1958 Corvette: Service Bulletin: Electric Windshield Wiper Information

Subject: Electric Windshield Wiper Information
Model and Year: 1958 Passenger Cars and Trucks
Source: Chevrolet Technical Service Bulletin
Bulletin No: DR #359
Section: I
Date: May 28, 1958

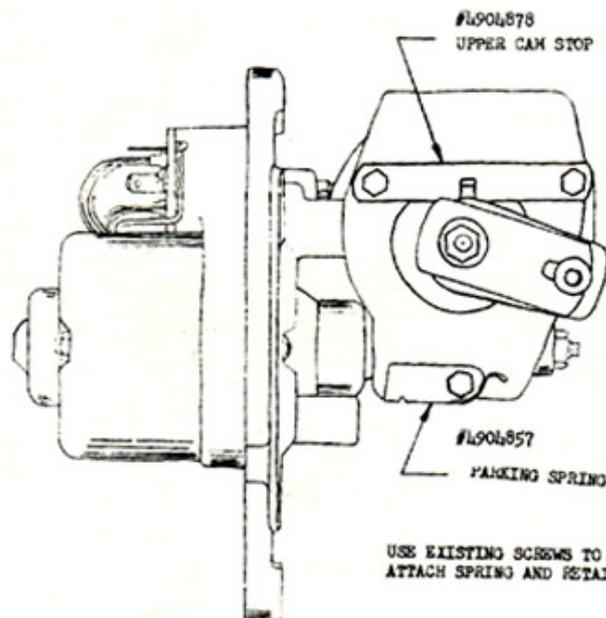
If loosening of the wiper motor on the support bracket or failure of the rubber "Wellnut" attachment is experienced, modify the "Wellnuts" and attach motor to bracket as shown in Figure #2.

FIGURE #1.

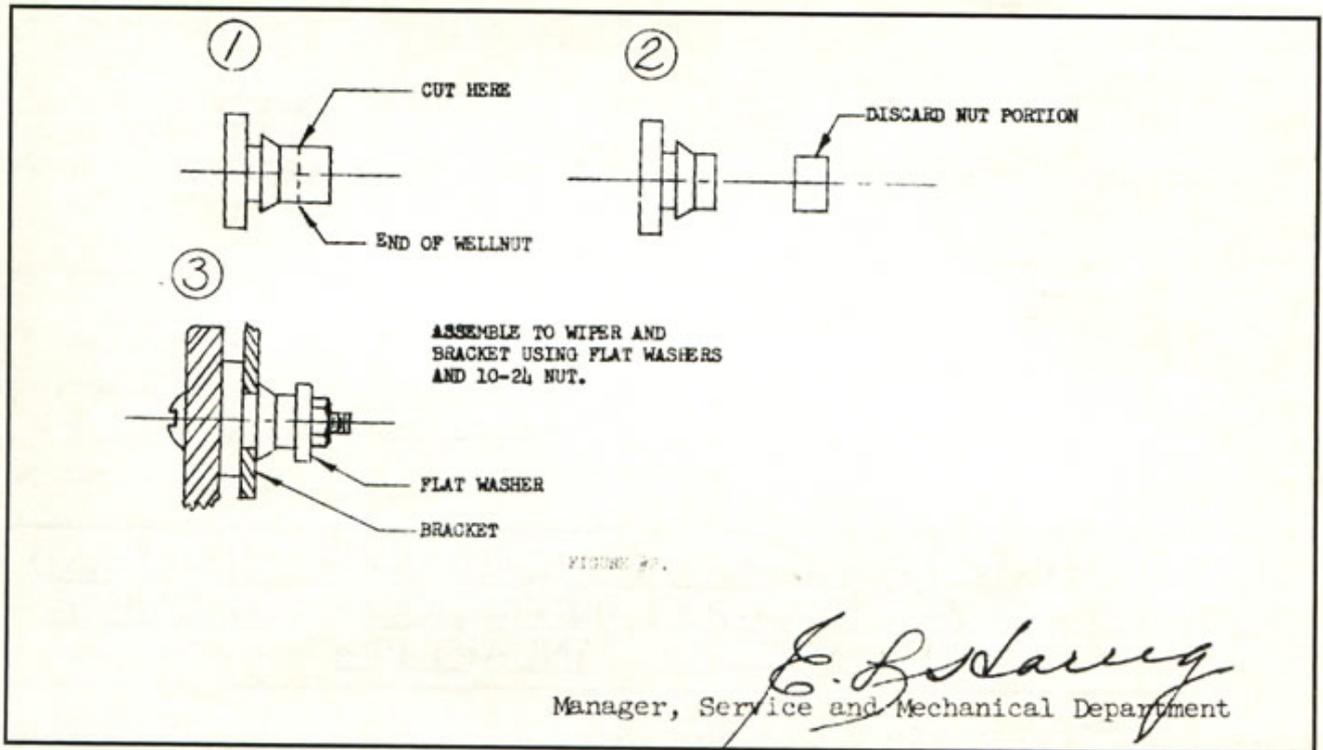
A parking spring has been released for production and service which enables the motor to shut off without depending on the resistance of the wiper blades. The spring is designed to clear the revolving arm in the "ON" position and stop the arm in the "PARK" position when switch is turned off. Figure #1 shows installation of parking spring.

A more durable replacement cam stop is available for service. Figure #1 shows details of installation. The existing tab must be bent flat before installation of the new stop.
